ERRATA

TO THE SN65LV1023A 10-MHz to 66-MHz, 10:1 LVDS Serializer/Deserializer DATA SHEET

(TEXAS INSTRUMENTS LITERATURE NO. SLLZ028, September 2003)

This document is an errata to the SN65LV1023A data sheet (Literature No. SLLS570).

Figure 1. Sync Pattern Generation

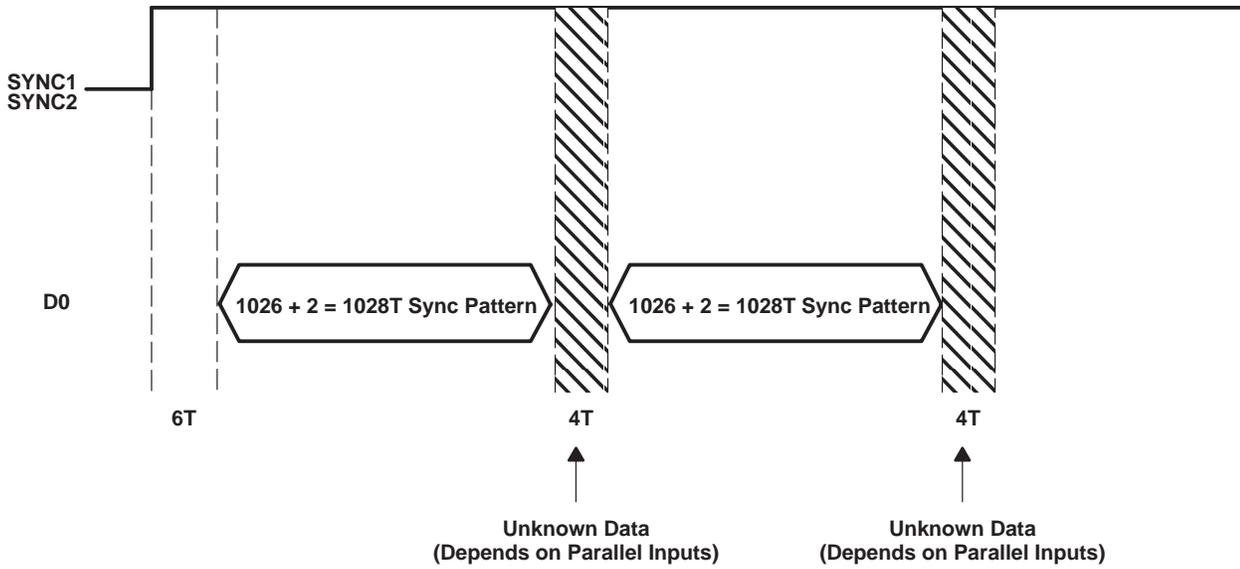
Case#2) SYNC1 or SYNC2 is held high continuously more than at least 1038T (6T to invoke the first series of SYNC pattern, and 1026T which is the duration of the first series of SYNC pattern, and 6T to invoke the second series of SYNC pattern):

If the sync pattern generator were to operate as it is intended, a user should be able to observe the continuous SYNC pattern on the serial line. For example, if the SYNC1 or SYNC2 is held high for 1039T, a user will see the SYNC pattern being generated continuously for 2052T ($=1026T+1026T$). However, as shown in Figure 1 the device behaves in a way that if the SYNC1 or SYNC2 is held high more than 1038T, it sends out 1028T of SYNC pattern plus 4T of data (which reflect the data that is present on the parallel input at that time) and another 1026T of SYNC pattern. Figure 1 basically shows what would happen to the data on the serial line if the SYNC1 or SYNC2 is held for an extended period of time.

No system impact was reported by customers due to this behavior. However, if the receiver is designed to require more than 1026T of SYNC pattern to lock, then user needs to understand the device behavior described previously.
